Valley Beam report Gridlines F-H

New Warehouse SIM Liverpool Road Manchester

Ref WS/22702/SIM/16-11-2024

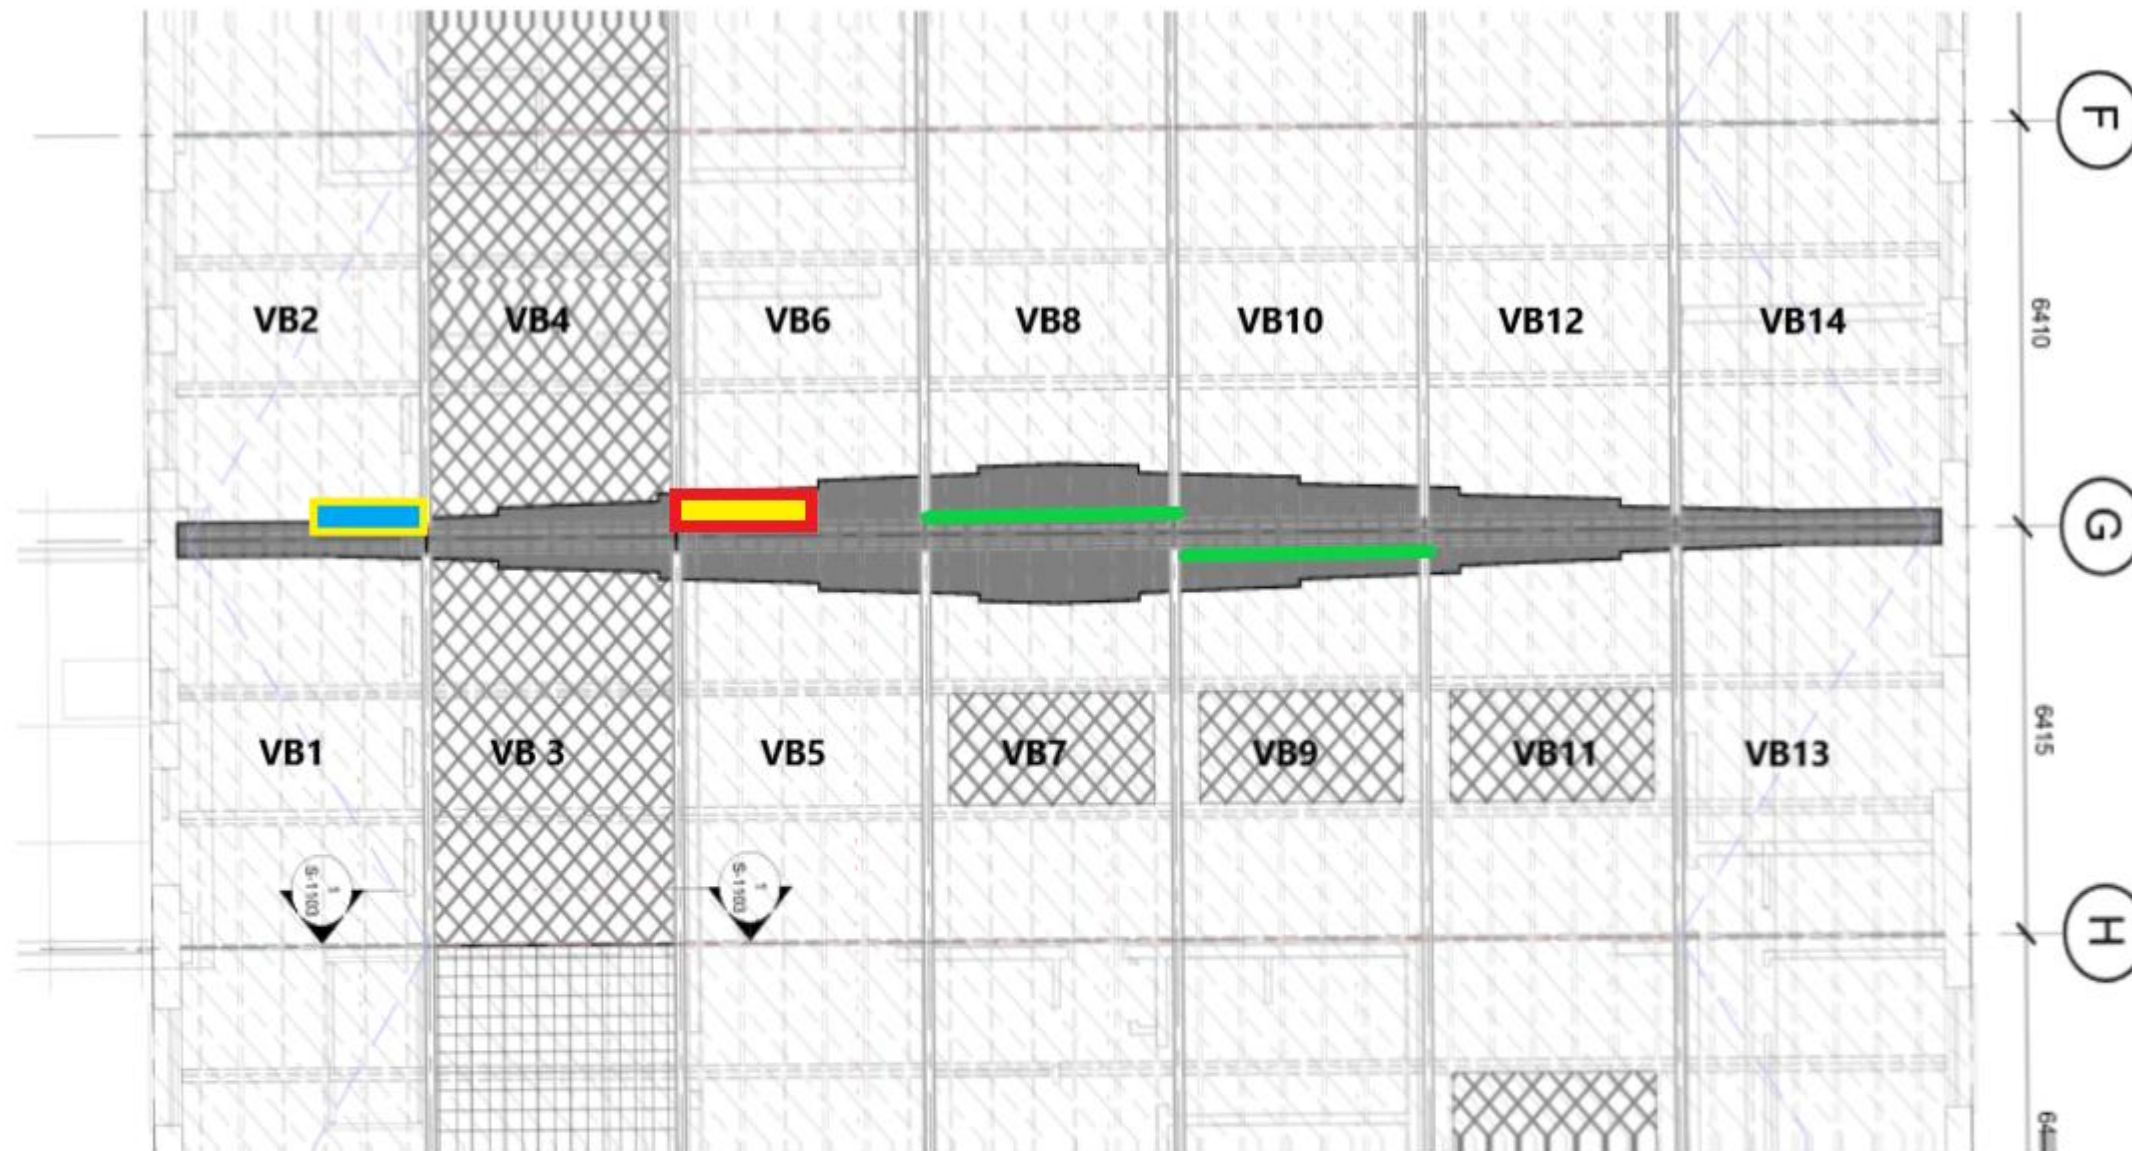
— Defrass decay from beam (Subject to SE ) and treat with Wykamol 10.1 fungicide gel

— Renew beam full length using C24 treated Douglas fir

— Steel flitch repair as per WML specifications and drawing

— — Cut out decay and splice new section of wood to beam
